June 25, 2003
ASARCO BLACK PINE MINE
2003 RECLAMATION PLAN FOR THE COMBINATION MINE AREA
DRAFT CHECKLIST ENVIRONMENTAL ASSESSMENT

COMPANY NAME: ASARCO

PROJECT: Black Pine Mine

**Forest Service Road 448 Relocation
and
ASARCO Land Purchase from USFS
Black Pine/Combination Mine, Lot 7**

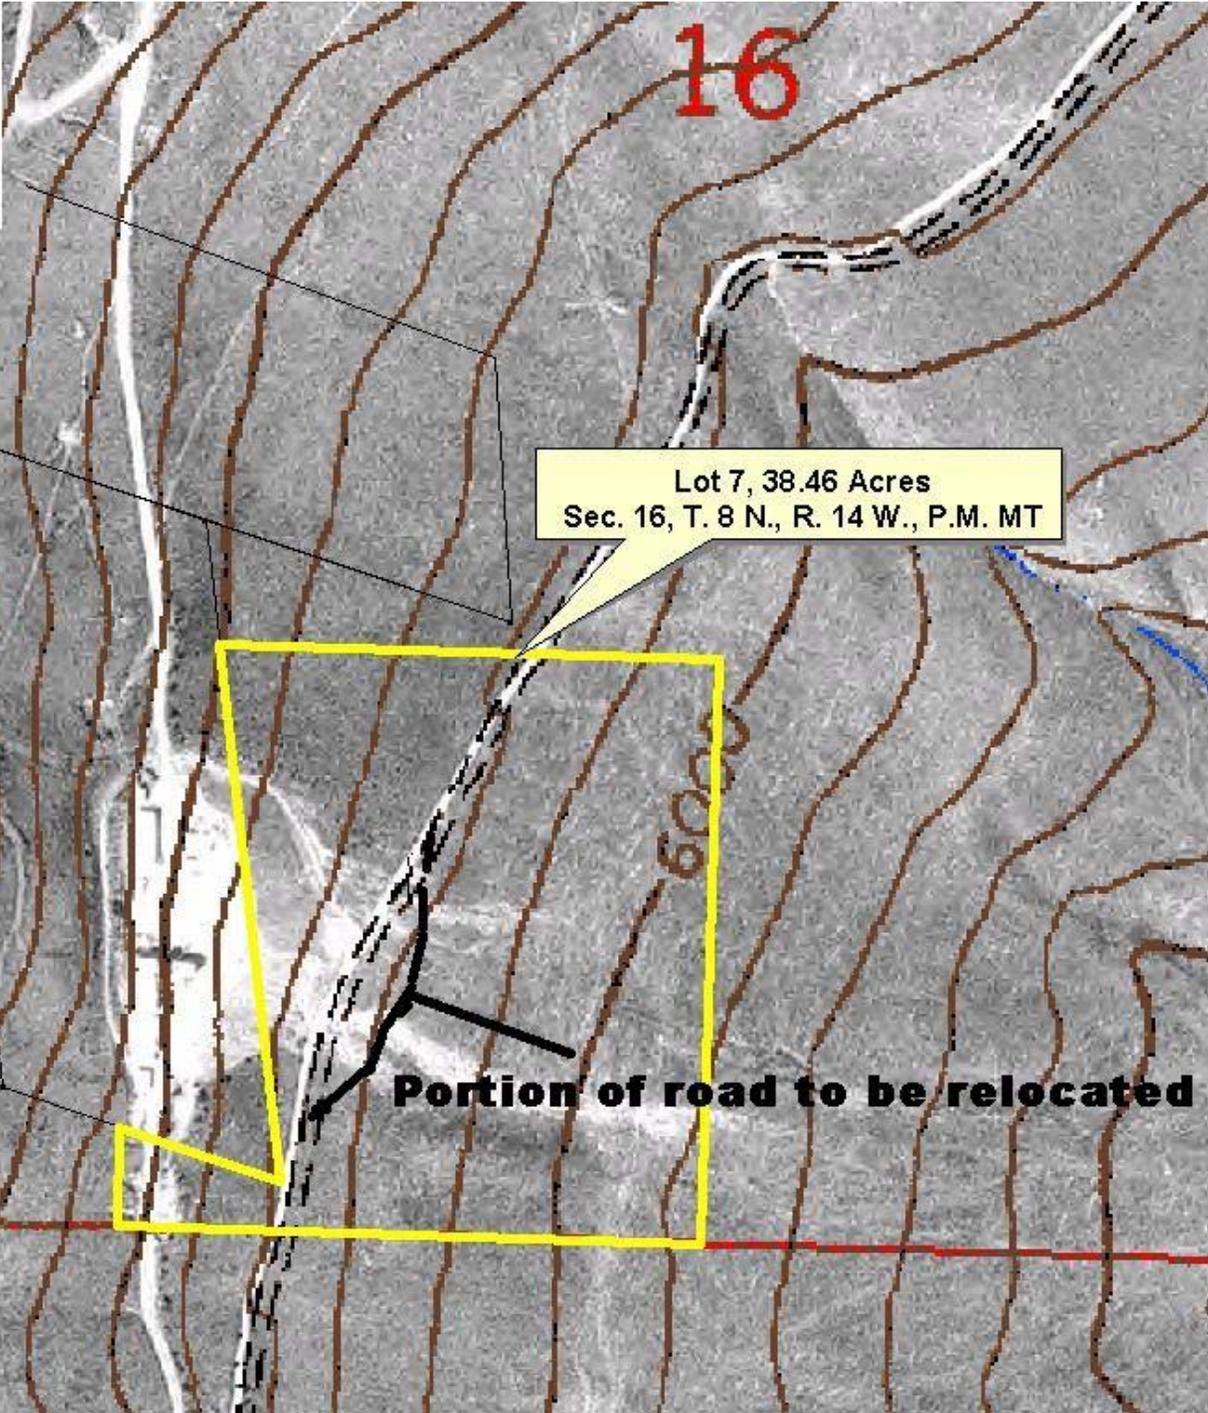
Modification 15: There are few details regarding the relocation and reconstruction of USFS Road 448. Additionally, the public must be informed about the construction activities and that the road may be blocked for a period of time during reconstruction.

Stipulation 15: ASARCO must submit a detailed construction plan for the relocation of USFS Road 448 below the waste rock dump for agency review and approval before construction begins. That plan must identify the anticipated quantities of fill to be removed and replaced and the source of that fill (also see Stipulation 4 above). The plan must also detail how the public will be informed about the construction and how long ASARCO anticipates the road would be closed and what efforts would be made, if possible, to maintain access across the area during construction.
